# Section 1

## Introduction

This *City of Los Angeles, Integrated Resources Plan Final Environment Impact Report* (Final EIR) presents the responses to comments received on the *City of Los Angeles, Integrated Resources Plan Draft Environment Impact Report*, or Draft EIR. (City of Los Angeles et al., 2005). In addition to providing responses to comments, this Final EIR presents the Recommended Alternative and also provides updates, where applicable, to the Draft EIR. The City of Los Angeles, Department of Public Works (LADPW) is the Lead Agency for the California Environmental Quality Act (CEQA) process and has evaluated, directed, and supervised the preparation of this document. In accordance with CEQA, the Draft EIR and this Final EIR, together, comprise the Lead Agency's environmental analysis of the *Integrated Resources Plan Facilities Plan* (IRP Facilities Plan) (City of Los Angeles et al., 2004).

**Figure 1-2**  
**GBIS Alignments**

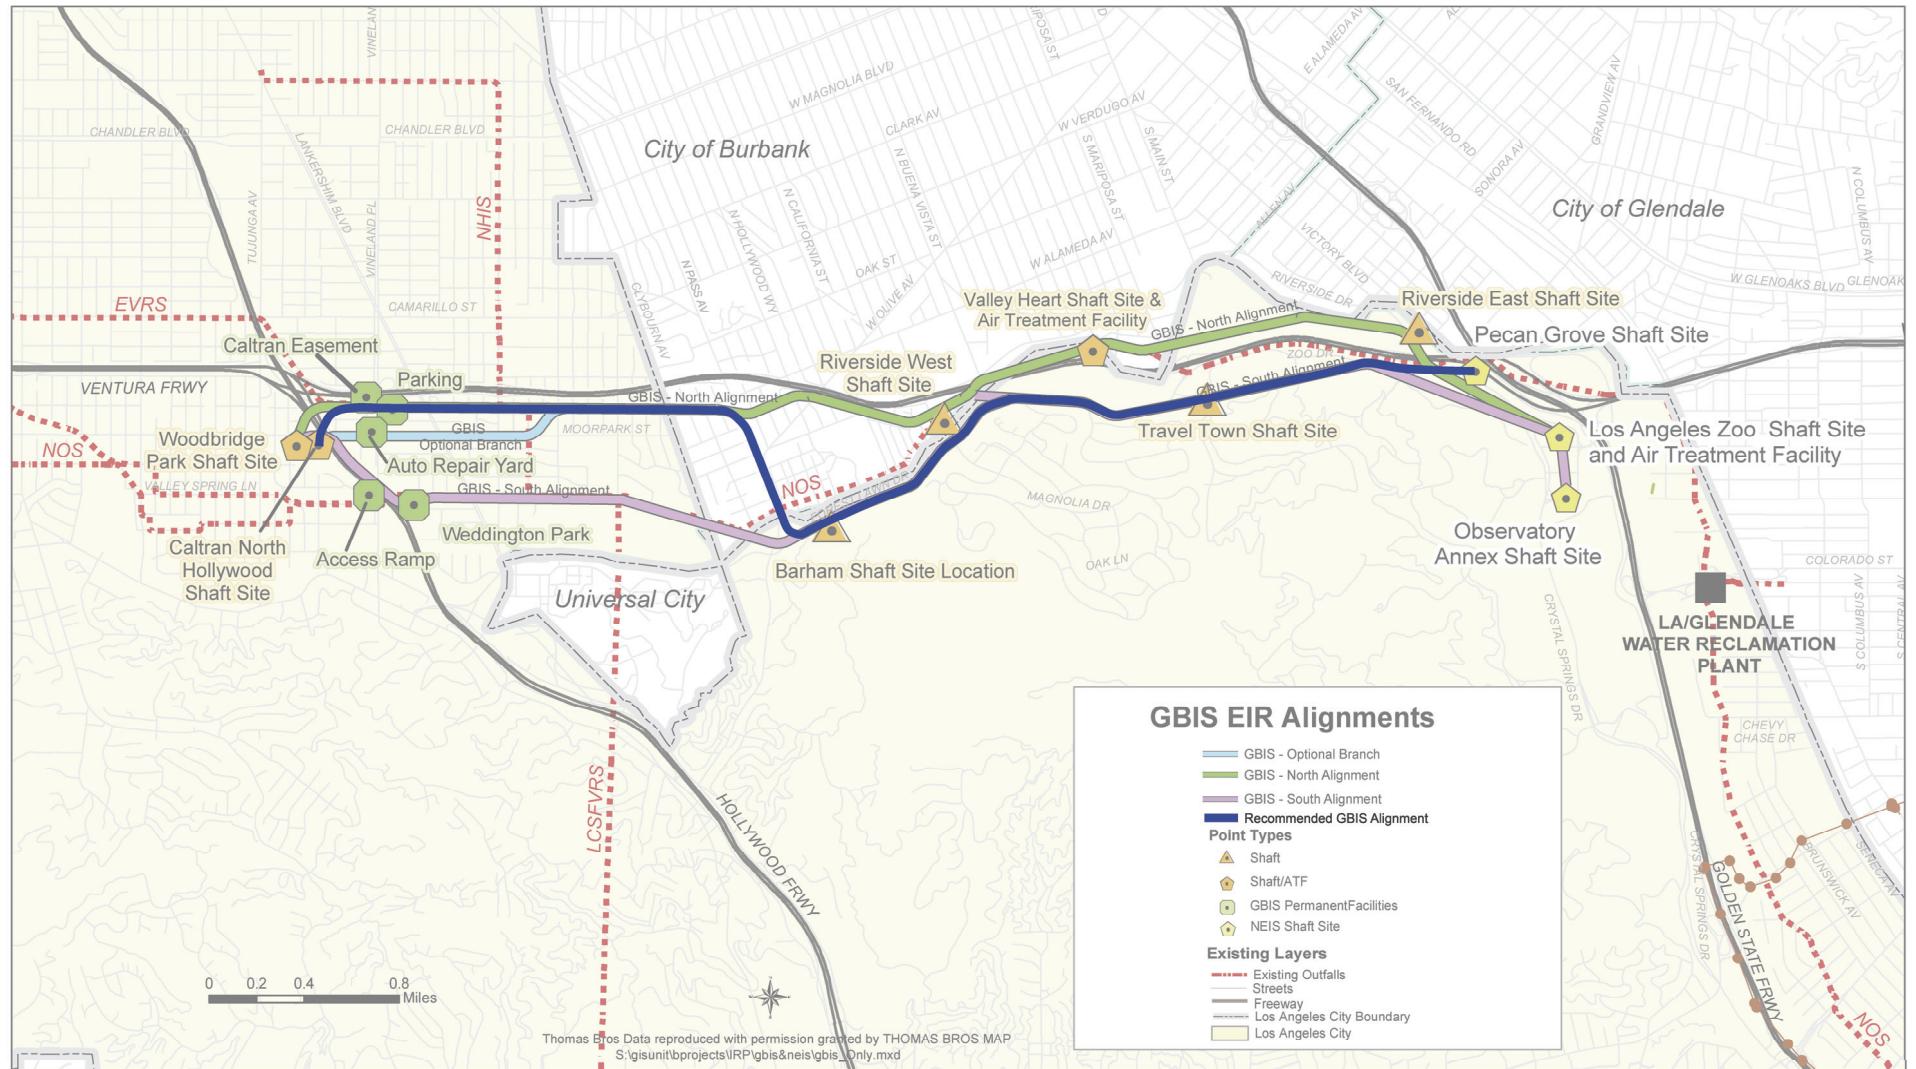
During the public comment period for the Draft EIR (see Section 1.3 of this Final EIR), numerous comments were received on the proposed alignments (see Section 3 of this Final EIR), including comments from the City of Burbank; City of Glendale; Forest Lawn Memorial Park Association and Forest Lawn Mortuary (Forest Lawn); and residents of the City of Burbank, City of Glendale, and community of Toluca Lake. Many of the commenters in the Burbank area expressed concern about potential GBIS construction and facilities at the Valley Heart Shaft Site, Riverside East Shaft Site, and Riverside West Shaft Site, all of which are located along the eastern half of the GBIS North Alignment. Toluca Lake area residents and Forest Lawn also commented on the GBIS South Alignment, in particular on the western portion of the GBIS South

Alignment. In addition, comments were received on a possible construction shaft site and air treatment facility (ATF) at Woodbridge Park.

The GBIS alignment recommended by staff for implementation connects the eastern half of the GBIS South Alignment and the western half of the GBIS North Alignment with a short section of tunnel beneath Pass Avenue in the City of Burbank. Figure 1-2 of this Final EIR shows this combined GBIS alignment overlaid on the GBIS South Alignment and the GBIS North Alignment, as described in the Draft EIR.

The staff recommended GBIS Alignment, depicted in blue in Figure 1-2, would be constructed using tunneling methods. Tunneling would occur from or between the following shaft sites (analyzed in the Draft EIR as part of the GBIS South Alignment):

**Figure 1-3**  
**Staff Recommended GBIS Alignment**

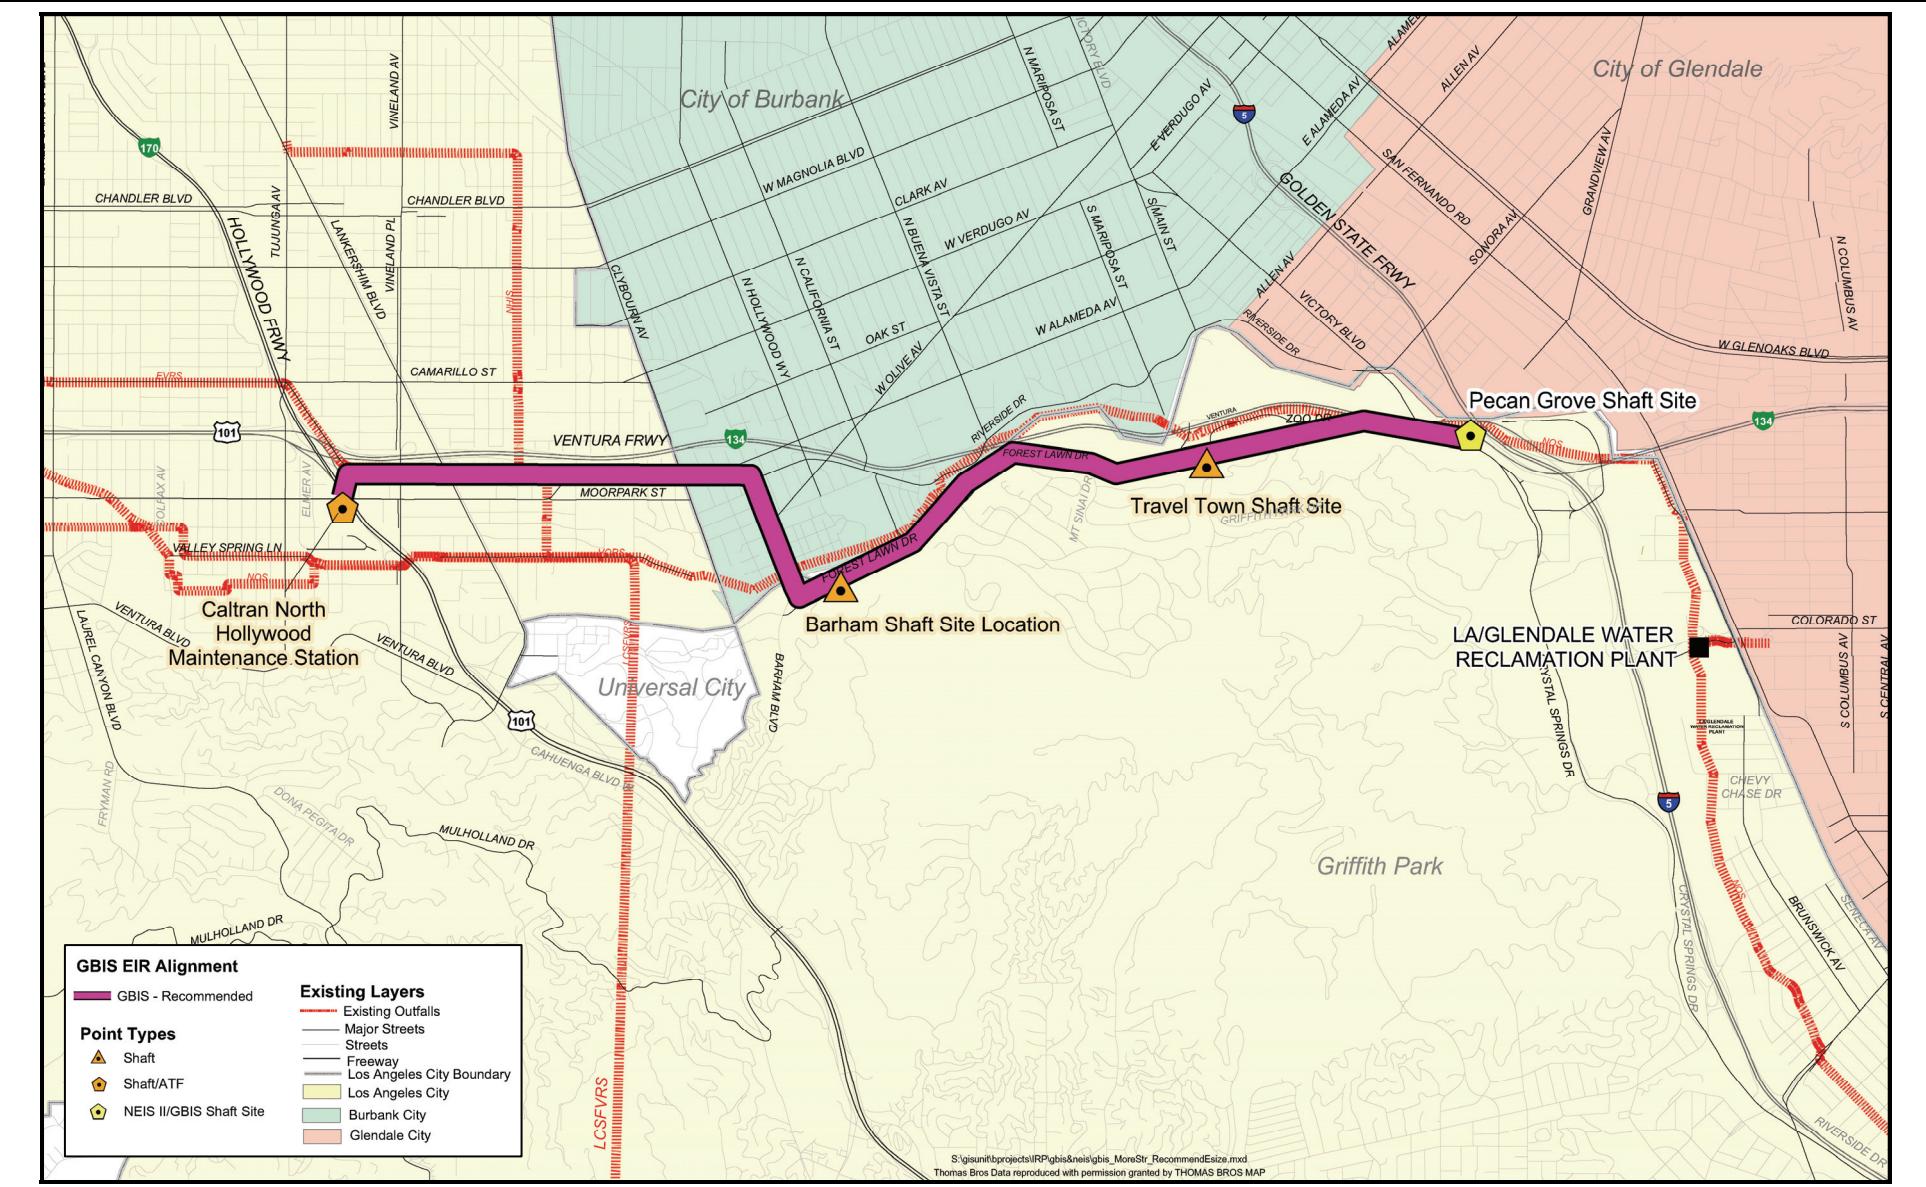
The staff recommended GBIS Alignment also would avoid impacts along the western portion of the GBIS South Alignment, as expressed in many of the comments received on the Draft EIR.

In addition, City staff met with various representatives of the City of Burbank (summarized in Section 1.3) to address concerns expressed by the City of Burbank regarding an alignment along Pass Avenue. Based on that coordination, the City of Los Angeles is incorporating the following voluntary measures into the design of the staff recommended GBIS Alignment:

Figure 1-3 shows the staff recommended GBIS Alignment and the construction shaft sites that are recommended for implementation.

- Maintenance hole structures. The City will attempt to eliminate the placement of maintenance hole structures within the City or Burbank, including along Pass Avenue.

- Tunneling Construction Sites. No tunneling construction sites would occur within the City of Burbank, unless a construction emergency situation requires such construction (no such construction emergencies are anticipated).

- Minimize or Prevent Surface Construction. Minimize, if not avoid, surface construction activities for GBIS in the City of Burbank, including along Pass Avenue.
